## **SN65LVPE502CP Errata**

The SN65LVPE502CP redriver is a dual channel, single lane USB 3.0 redriver and signal conditioner supporting data rates of 5.0Gbps. This report provides information on the errata found on the SN65LVPE502CP device. The errata includes a false detect with VBUS powered devices and termination remaining enabled in certain situations.

**Figure 1. Connection of VBUS Powered Device**

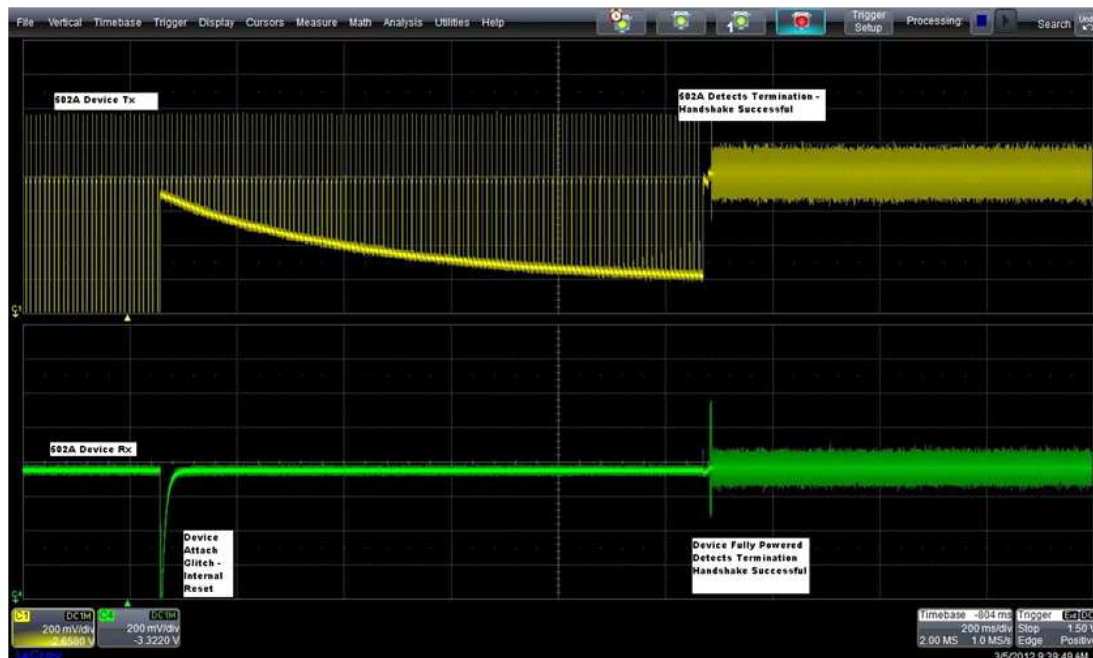
**Problem:**                    *False Detect*

*Some VBUS powered devices create noise on plug-in and cause the SN65LVPE502CP to falsely detect the device and enable termination early. After termination is enabled, the host begins polling before the device is ready. Polling will timeout and the host will enter compliance mode.*

**Solution:**                    This issue is fixed on the SN65LVPE502A device. [Figure 1](#) shows a successful connection after a glitch is observed when the VBUS powered device is attached.

**Figure 2. SN65LVPE502A Successful Disconnect**

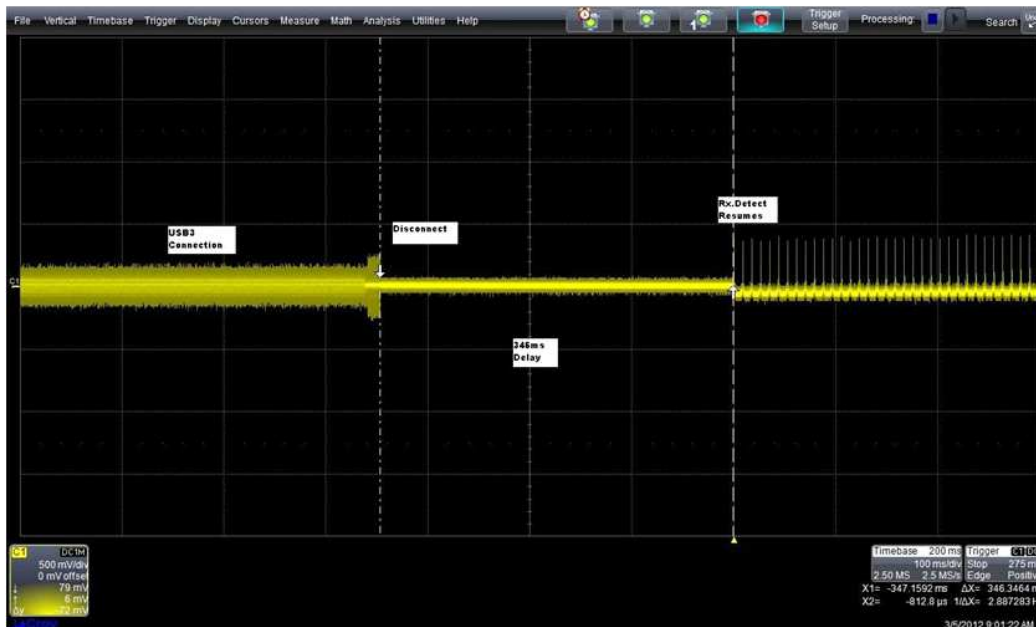
**Problem:** *Termination Remains Enabled*

*In certain conditions the termination remains enabled after a device is disconnected from the SN65LVPE502CP. This issue is host software driver dependant. If host issues a warm reset within ~300 ms of device disconnect the termination will remain enabled. No functional issues are observed, but the power consumption is increased while no devices are connected.*

**Solution:** This issue is no longer driver dependant and is fixed in the SN65LVPE502A. A successful disconnect may be observed in [Figure 2](#).
